Title - Sujet Bowden Roof Upgrade	
Solicitation No. - N° de l'invitation EP922-183351/A	Amendment No. - N° modif. 002
Client Reference No. - N° de référence du client CSC	Date 2018-05-07
GETS Reference No. - N° de référence de SEAG PW-\$PWU-183-11355	
File No. - N° de dossier PWU-7-40267 (183)	CCC No./N° CCC - FMS No./N° VME
Solicitation Closes - L'invitation prend fin at - à 02:00 PM on - le 2018-05-14	Time Zone Fuseau horaire Mountain Daylight Saving Time MDT
F.O.B. - F.A.B. Plant-Usine: <input type="checkbox"/> Destination: <input type="checkbox"/> Other-Autre: <input type="checkbox"/>	
Address Enquiries to: - Adresser toutes questions à: Tikhonovitch (RPC), Alex	Buyer Id - Id de l'acheteur pwu183
Telephone No. - N° de téléphone (780) 901-7940 ()	FAX No. - N° de FAX (780) 497-3510
Destination - of Goods, Services, and Construction: Destination - des biens, services et construction:

Addendum No. 1

Project #: R.083696.001
Project Name: BOWDEN INSTITUTION, A18
REPAIR AND B21 ROOF REPLACEMENT

ASK. # 1

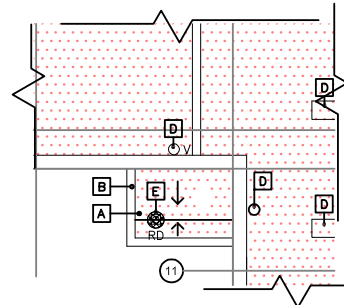
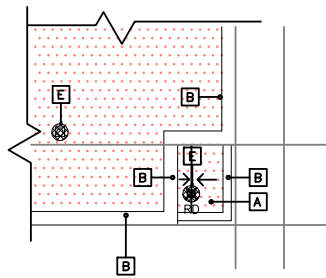
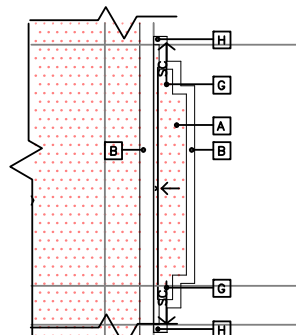
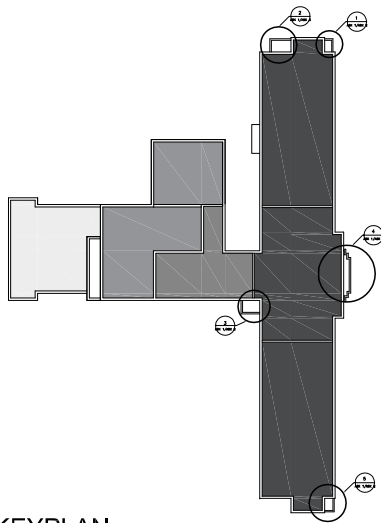
Item 5. Clarification: small roof areas to be included on the scope of work, refer to attached ASK #1&2 for locations.

- [A] REMOVE EXISTING ROOF SYSTEM DOWN TO EXISTING ROOF DECK TYPICAL.
- [B] REMOVE EXISTING CAP FLASHING ON PARAPETS.
- [D] REMOVE EXISTING FLASHING.
- [E] REMOVE EXISTING ROOF DRAINS TO BE REPLACED.
- [G] EXISTING SCUPPER TO BE REPLACED.
- [H] EXISTING DOWNSPOUT TO BE REPLACED.
